Re: St. Lucie Plant Unit 1
Docket No. 50-335
Renewed Facility Operating License No. DPR-67

Supplemental Information for the Extended Power Uprate License Amendment Request
Related to the Post-Loss of Coolant Accident (LOCA) Boric Acid Precipitation Analysis

Supplemental Information for LAR Attachment 5 Section 2.8.5.6.3.5, Technical Evaluation – Post LOCA Boric Acid Precipitation.

Figure 1
Updated Boric Acid Precipitation Analysis
Boric Acid Concentration in the Core versus Time

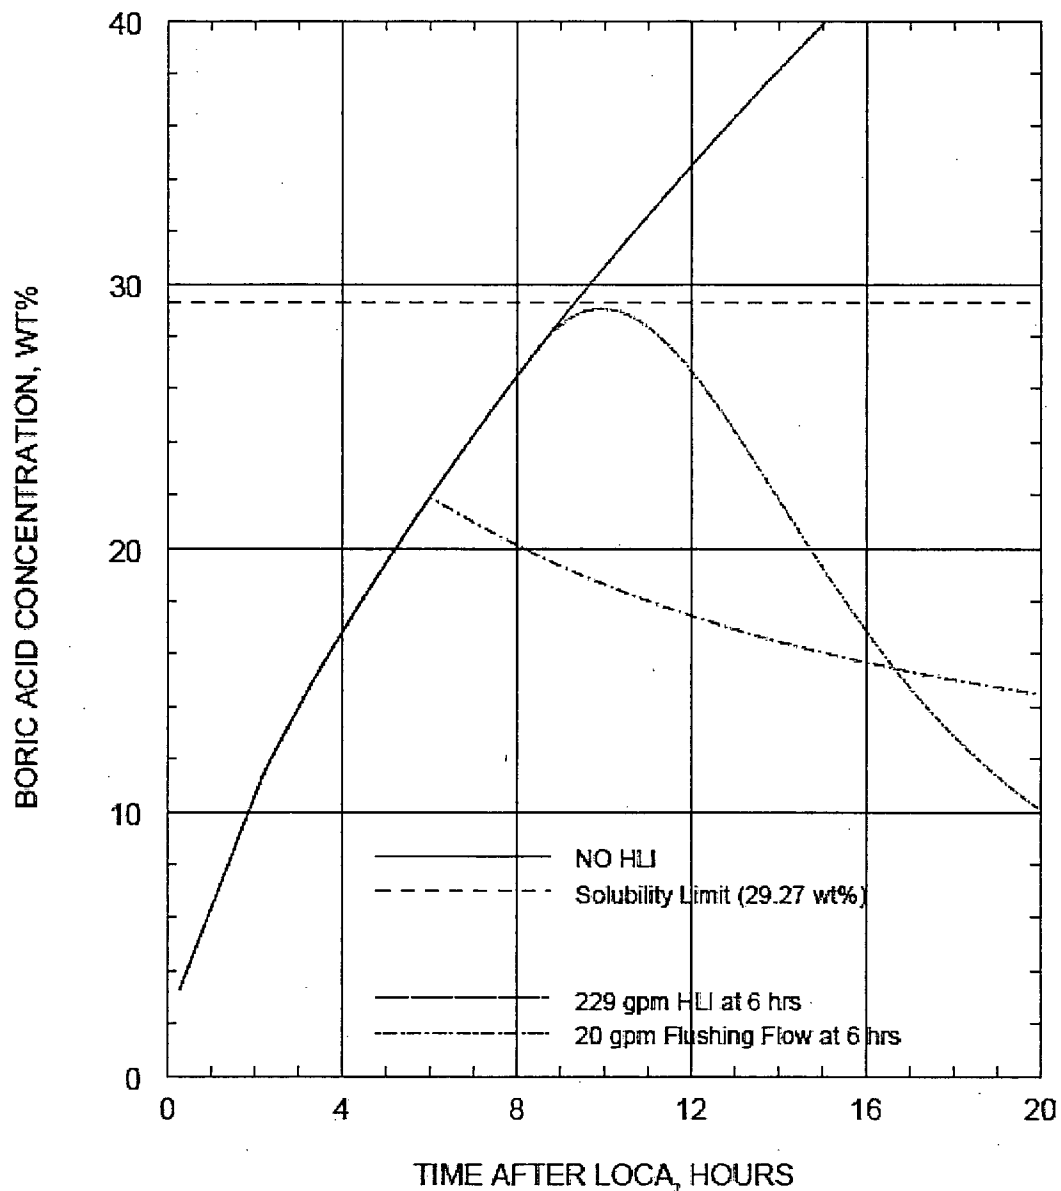
Figure 1 shows the results of the post-LOCA boric acid precipitation analysis by comparing the boric acid concentration as a function of time for HLI flow rate of 229 gpm and a flushing flow of 20 gpm.
